SUBSURFACE SEWAGE TREATMENT SYSTEM COMPLIANCE REPORT

Inspection Address: 264 Dwinnell Ave, Mahtomedi, MN 55115

Compliance Inspection Form
Existing Subsurface Sewage Treatment Systems (SSTS)

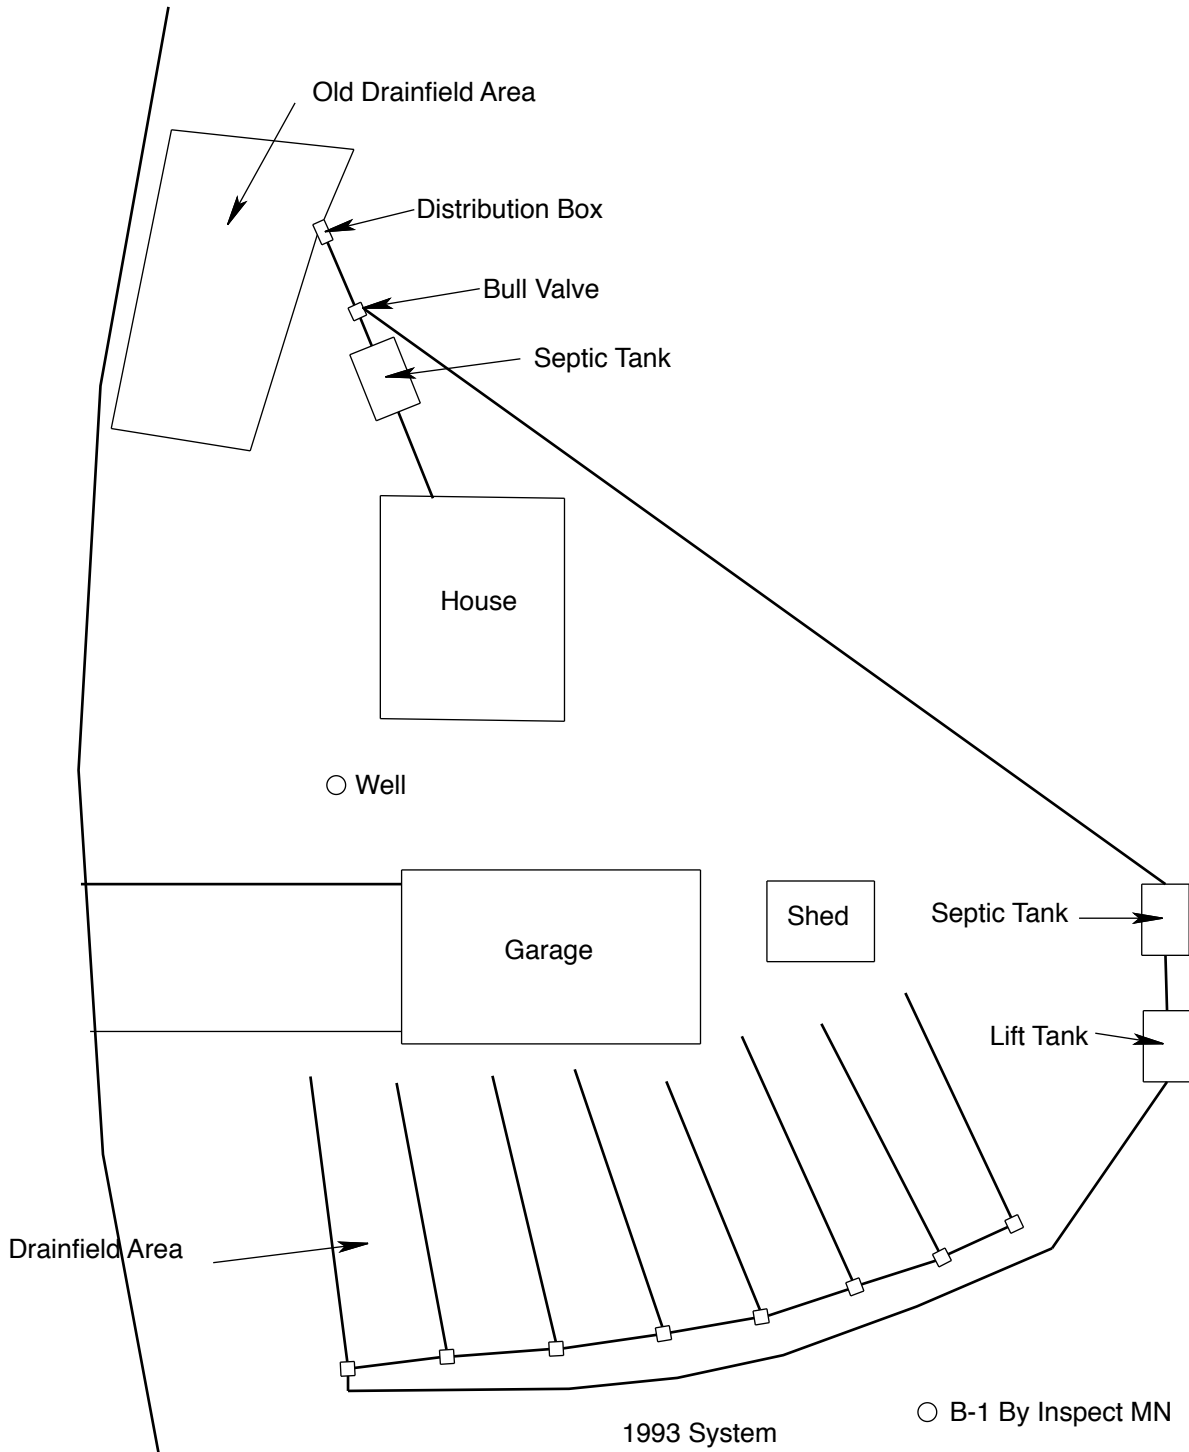
Are the tank maintenance covers accessible? <input checked="" type="checkbox"/> Yes <input type="checkbox"/> No *If no, proper maintenance must be performed through the maintenance holes. Maintenance hole covers should be made accessible to the ground surface to facilitate access and proper maintenance of the system.			
Year house built: 1942	Year septic installed: 1993	Tank size (gals.): 1-1250 1-1000	
How long has seller owned the property?		Number of residents in home?	
Number of bedrooms? 3	Are all floors drained by gravity? Y		
Garbage disposal?	Whirlpool bath?		
More than one system (laundry, etc.)?			
Does this property have any footing drain tiles connected to the septic system?			
Are any buildings on this property such as garages or out-buildings connected to this system?			
Are there any additional systems on this property serving other buildings?			
Location of septic system on lot? Tank/Old Drainfield - E Side, Tanks/New Drainfield - W Side

Location of water well on lot? North side		Is the well a deep well? Y	
Have you ever experienced any problems with the system such as: tree roots, sewage back-ups, surfacing of sewage onto the ground, septic tank overflowing, etc.; or have any repairs been made to the system? Y If yes, explain: Installed new septic tank in 2005.			
When was the system last pumped? 2011		Name of pumper:	
How often pumped in previous years? Due For Pump		Is system on a monitoring plan?	
Have you received notices from any government agency concerning this system?			
Is your property located in a shoreland management area? Y			
Do you have any additional information that should be given to the new owner?
